CITY OF ALBUQUERQUE

March 12, 2018

RE: **Montessori on the Rio Grande Charter School**
1650 Gabaldon Dr NW
Grading and Drainage Plan
Engineer's Stamp Date 3/6/18
Hydrology File: H12D008B

C102

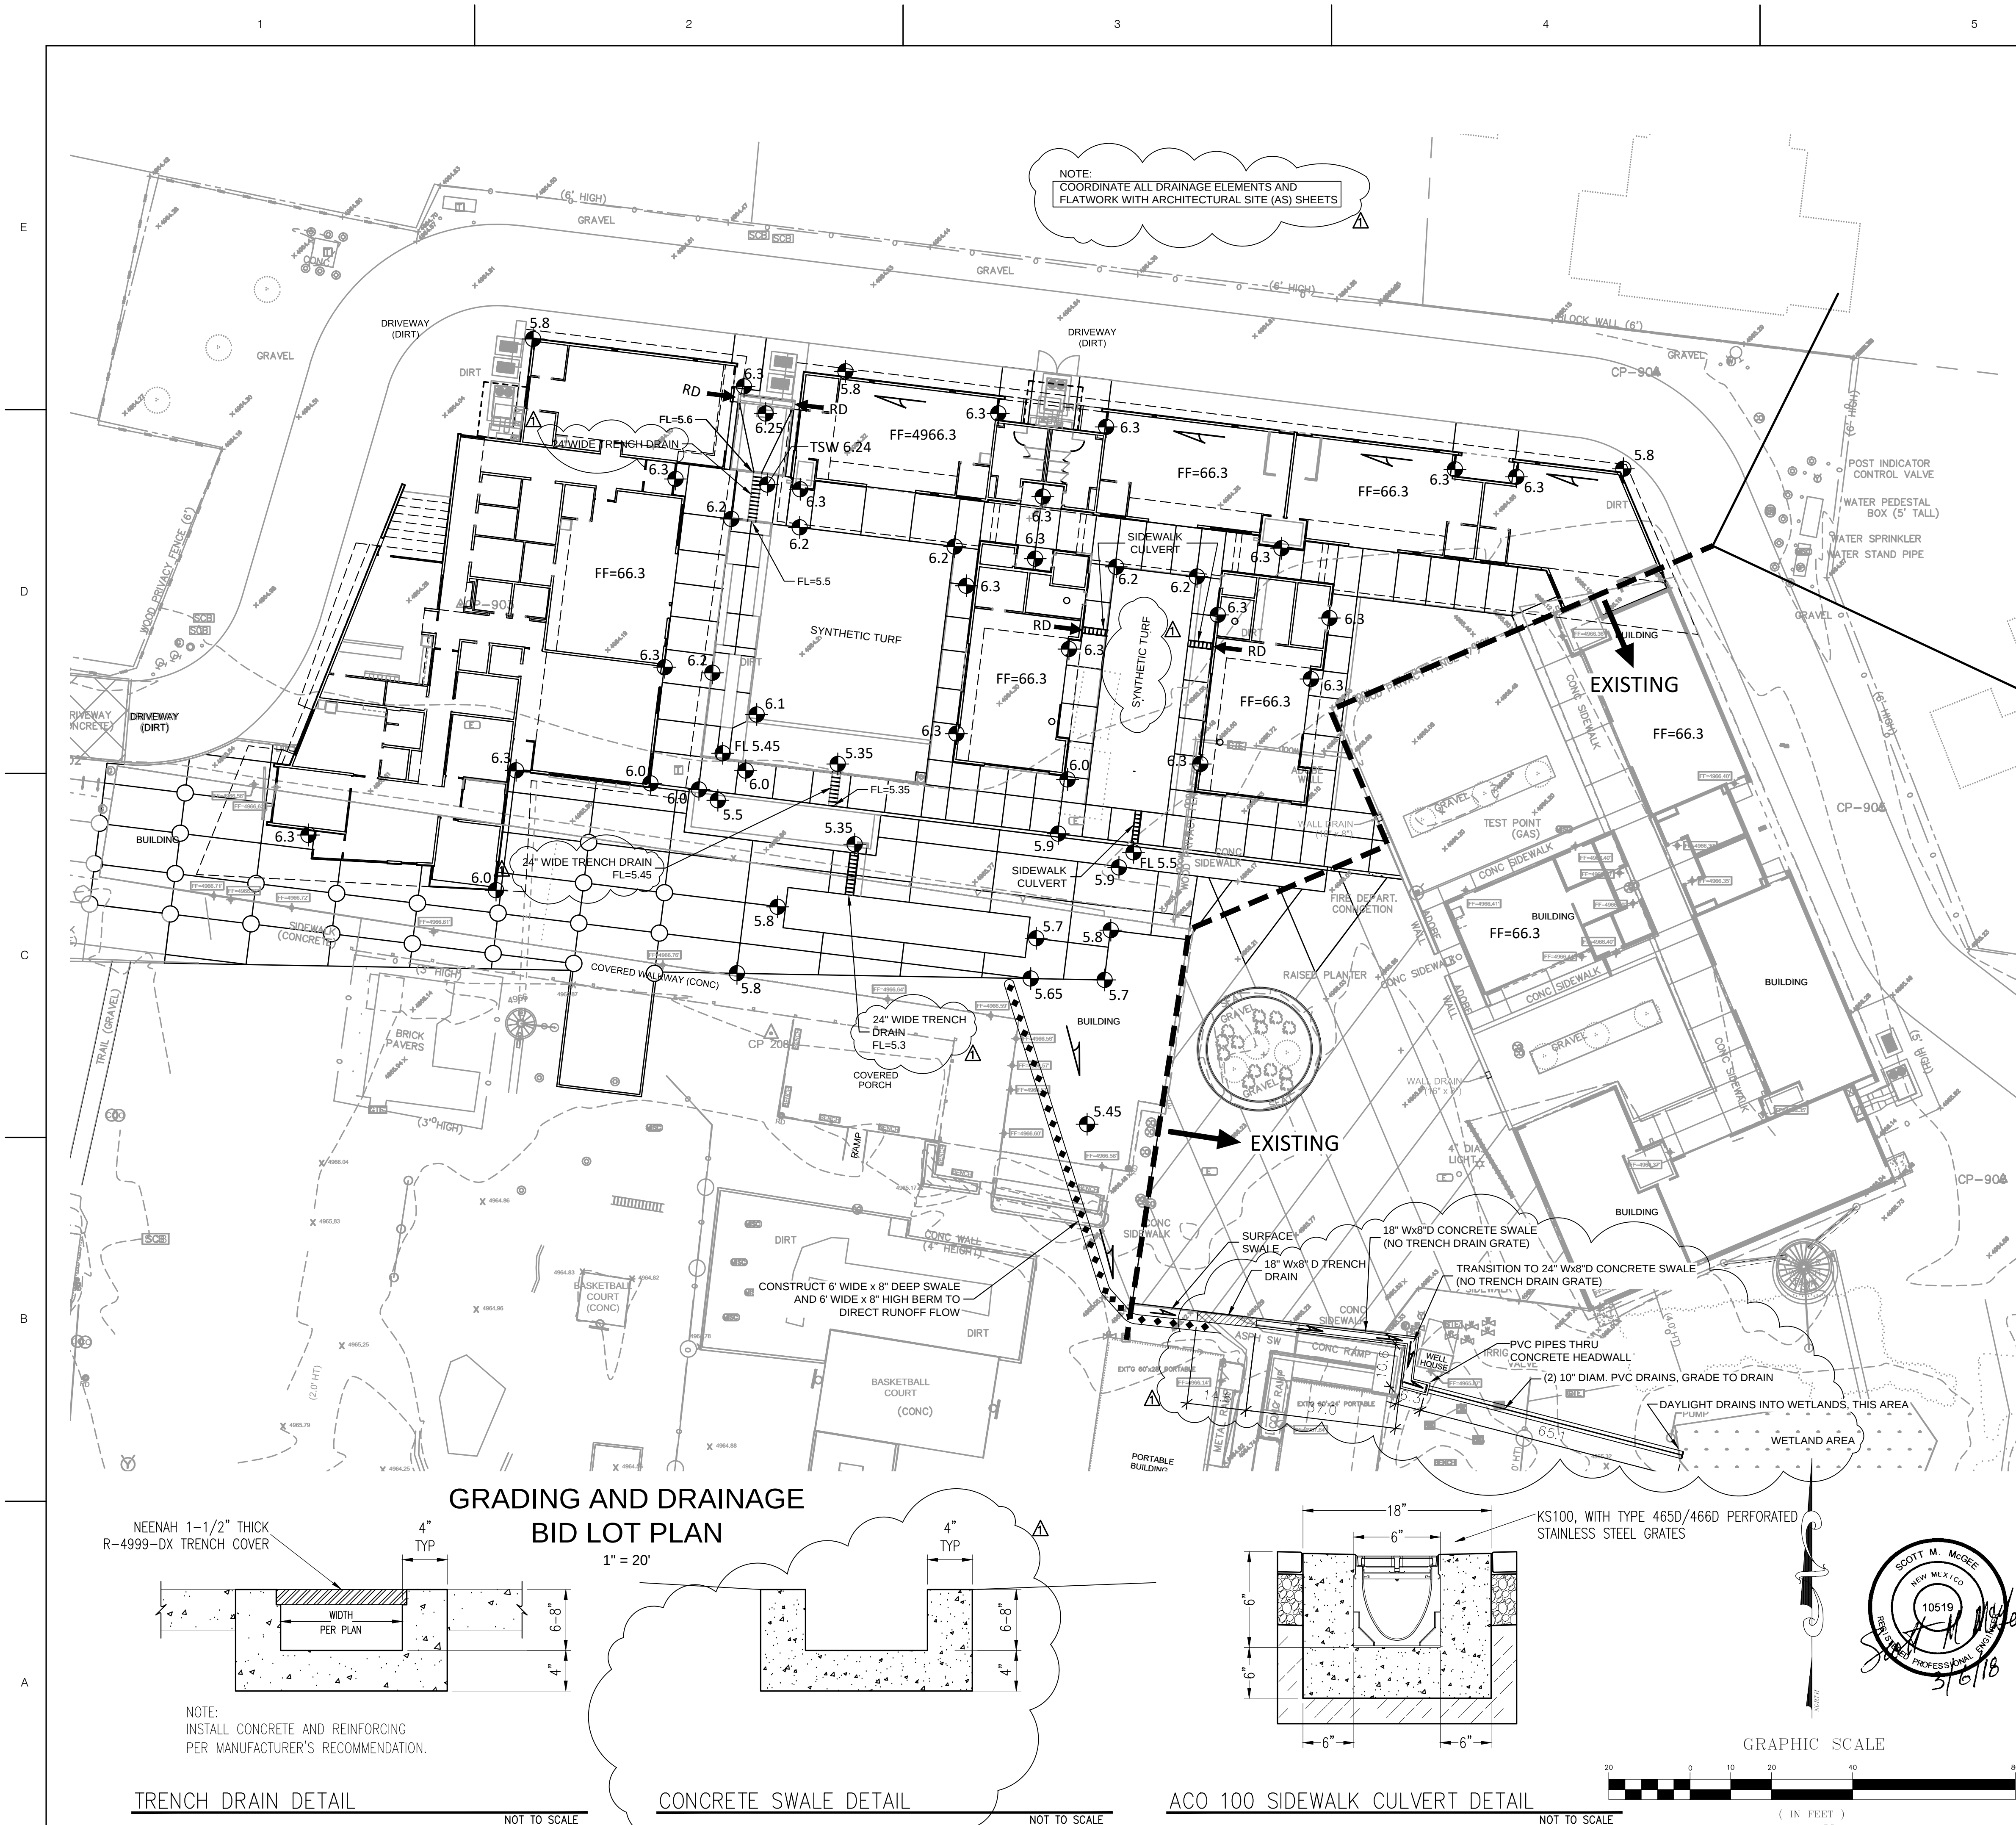
Based on the information provided in your submittal received 3/9/18, the above referenced plan cannot be approved for Building Permit until the following are addressed:

- PO Box 1293
- Albuquerque
- NM 87103
- www.cabq.gov
1. Onsite retention of the increased runoff needs to be substantiated. The increase appears to be ~2200CF (100-yr, 10day volume increase), yet only 1200CF of new storage is provided.
 - o If the existing wetland has additional storage capacity, please provide the supporting pond volumes and hydrology for it.
 - o If pond routing is being used to shave the peak flow, please provide that analysis.
 2. A Private Facility Drainage Covenant is required for the stormwater ponds. The original notarized form, exhibit A (legible on 8.5x11 paper), and recording fee (\$25, payable to City of Albuquerque) must be turned into DRC (4th, Plaza del Sol) for routing. Please contact Charlotte LaBadie (clabadie@cabq.gov, 924-3996) or Madeline Carruthers (mtafoya@cabq.gov, 924-3997) regarding the routing and recording process for covenants.
